Well Name: BIG EDDY UNIT 30E SKYWALKER	Well Location: T20S / R31E / SEC 14 / NWSW / 32.570285 / -103.8471	County or Parish/State: EDDY / NM
Well Number: 102H	Type of Well: OIL WELL	Allottee or Tribe Name:
Lease Number: NMLC0063667, NMLC063667	Unit or CA Name: BIG EDDY	Unit or CA Number: NMNM68294X
US Well Number: 3001546933	Well Status: Approved Application for Permit to Drill	Operator: XTO PERMIAN OPERATING LLC

Sundry ID: 2715002

Type of Submission: Notice of Intent	Type of Action: APD Change
Date Sundry Submitted: 02/09/2023	Time Sundry Submitted: 12:56
Date proposed operation will begin: 02/09/2023

Procedure Description: XTO Permian Operating, LLC. is requesting corrected COAs based on conversation with Allison Morency. **Casing & Cement Change XTO Permian Operating, LLC requests permission to make the following changes to the original APD: Casing and cement changes due to US supply chain issues. Updated drilling program is attached. Attachments: Drilling Program MBS Diagram

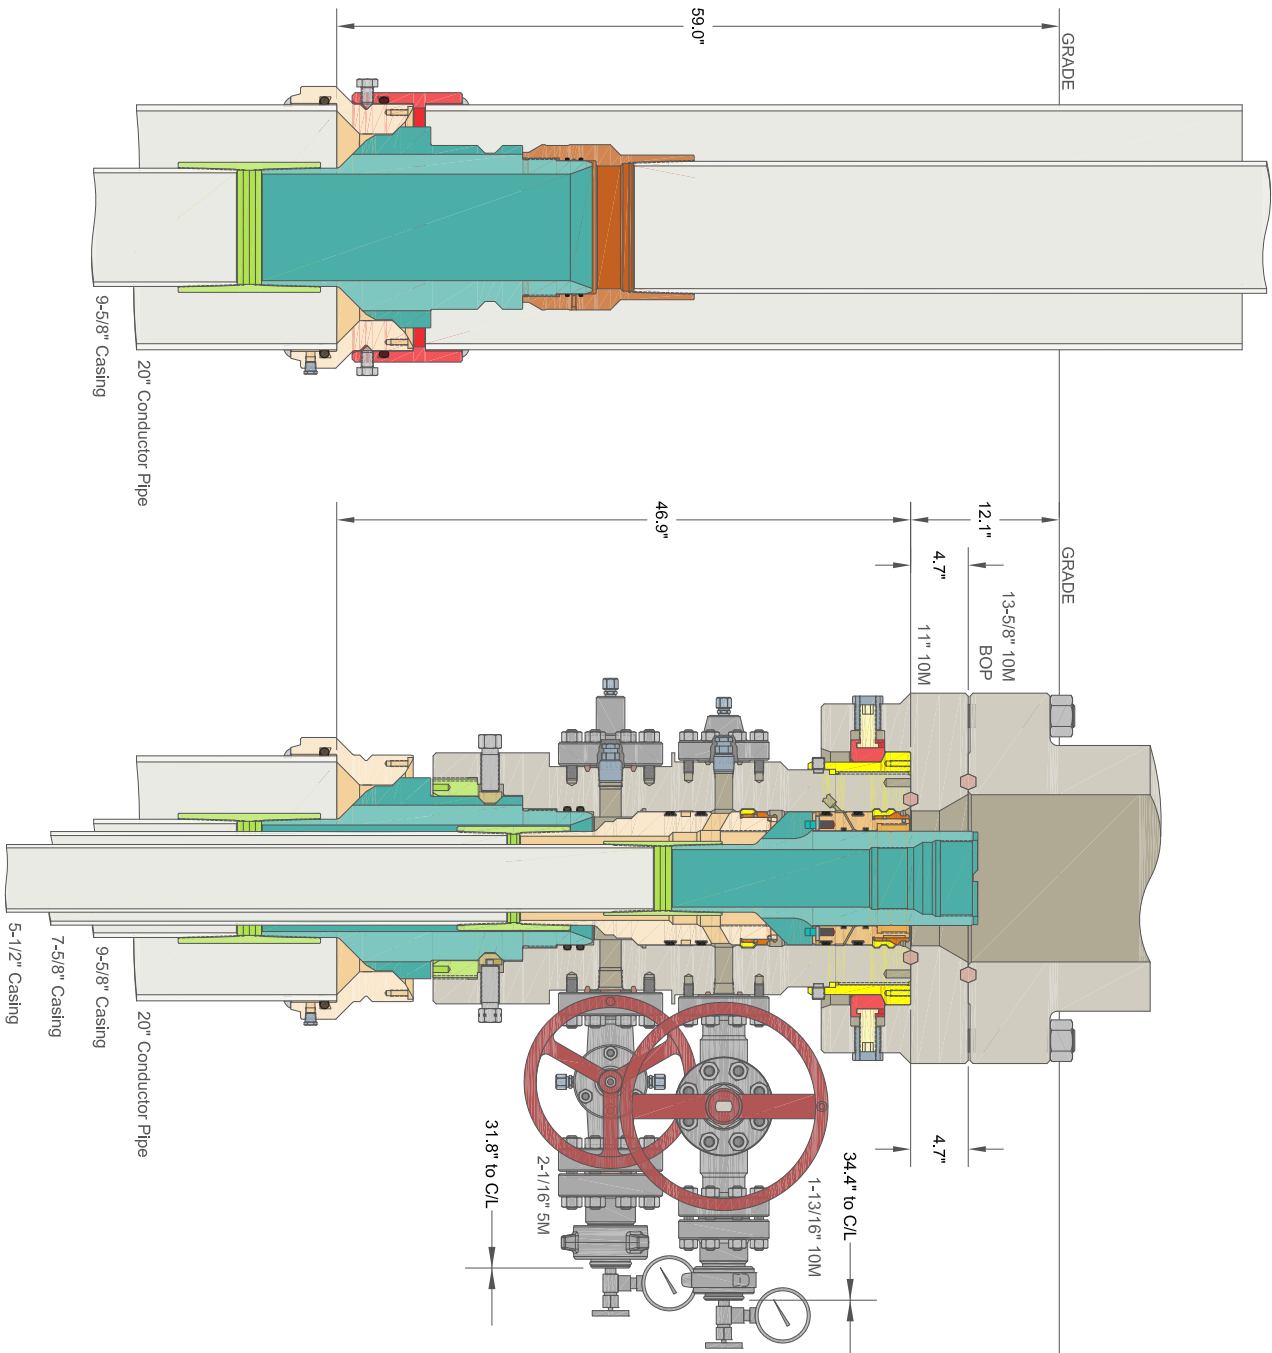
Permanent Wellhead – Multibowl System

A. Starting Head: 13-5/8" 10M top flange x 13-3/8" bottom

B. Tubing Head: 13-5/8" 10M bottom flange x 7-1/16" 15M top flange

- Wellhead will be installed by manufacturer's representatives.
- Manufacturer will monitor welding process to ensure appropriate temperature of seal.
- Operator will test the 9-5/8" casing per BLM Onshore Order 2
- Wellhead Manufacturer representative will not be present for BOP test plug installation

2. Operator has proposed a multi-bowl wellhead assembly. This assembly will only be tested when installed on the surface casing. Minimum working pressure of the blowout preventer (BOP) and related equipment (BOPE) required for drilling below the surface casing shoe shall be **2000 (2M)** psi.

- a. Wellhead shall be installed by manufacturer's representatives, submit documentation with subsequent sundry.
 - b. If the welding is performed by a third party, the manufacturer's representative shall monitor the temperature to verify that it does not exceed the maximum temperature of the seal.

- c. Manufacturer representative shall install the test plug for the initial BOP test.
 - d. If the cement does not circulate and one inch operations would have been possible with a standard wellhead, the well head shall be cut off, cementing operations performed and another wellhead installed.

- e. Whenever any seal subject to test pressure is broken, all the tests in OOGO2.III.A.2.i must be followed.
